5.2 SEPP 65 Consideration

5.3 Traffic Impact Assessment

Figure 11: Site access arrangements (indicative scheme Group GSA Indicative Scheme)

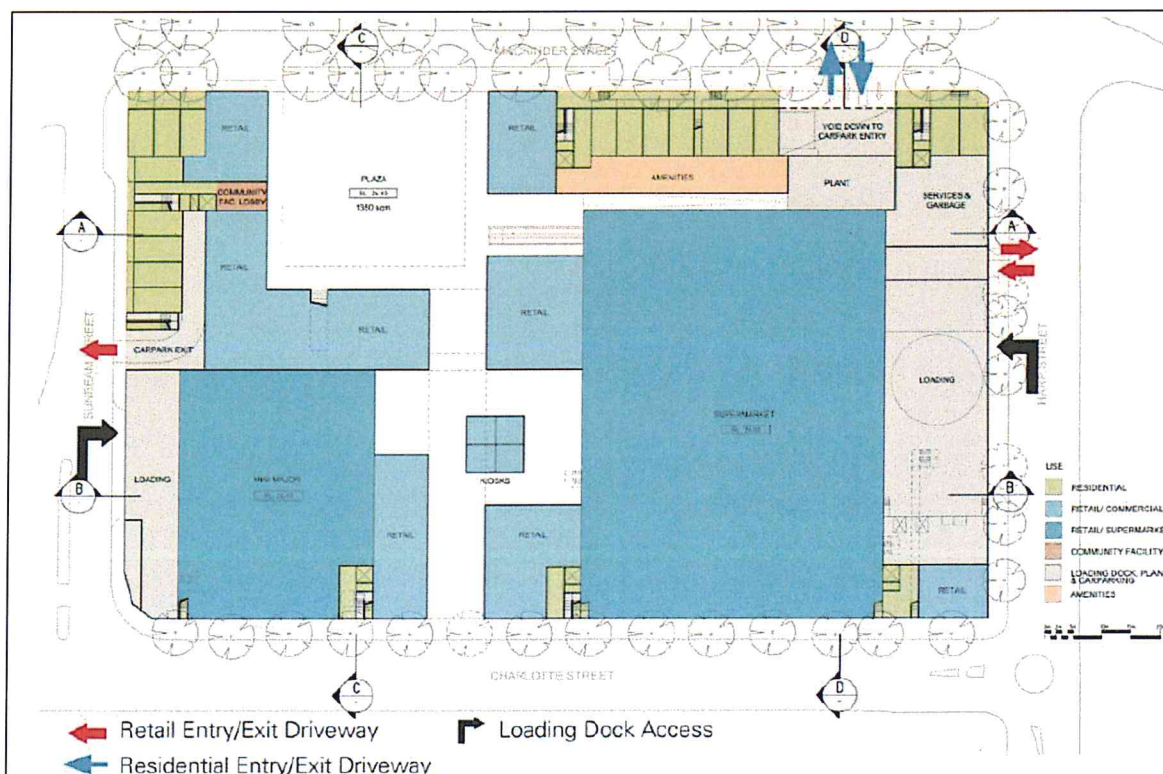
The department notes that the Aurecon review raised no major concerns with the location of the loading docks and that the detailed design will be assessed with the future development application. Subject to the final design satisfying the Future Assessment Requirements, the department raises no objection with the proposed access locations.

Whilst the department acknowledges that the loading docks are required to service the development, concerns are raised regarding the potential for their design and use to compromise the amenity of the residential uses on site and the surrounding residential areas (refer to discussion in **Section 5.2**). The department considers it to be preferable for the loading docks to be internalised to minimise the noise and visual impact to the surrounding residential areas. Accordingly, the department has included a Future Assessment Requirements to address this matter including the requirement for the proponent to analysis various design options prior to detailing the design for the loading docks in a future development application.

As detailed in Section 5.2, an additional Future Assessment Requirements is recommended to require an acoustic report to be submitted with the future development application to demonstrate that appropriate acoustic attenuation measures have been incorporated into the building design in order to minimise noise impacts generated by the use of the loading dock (in addition to the car parks, amenities, building plant and servicing areas in the development).
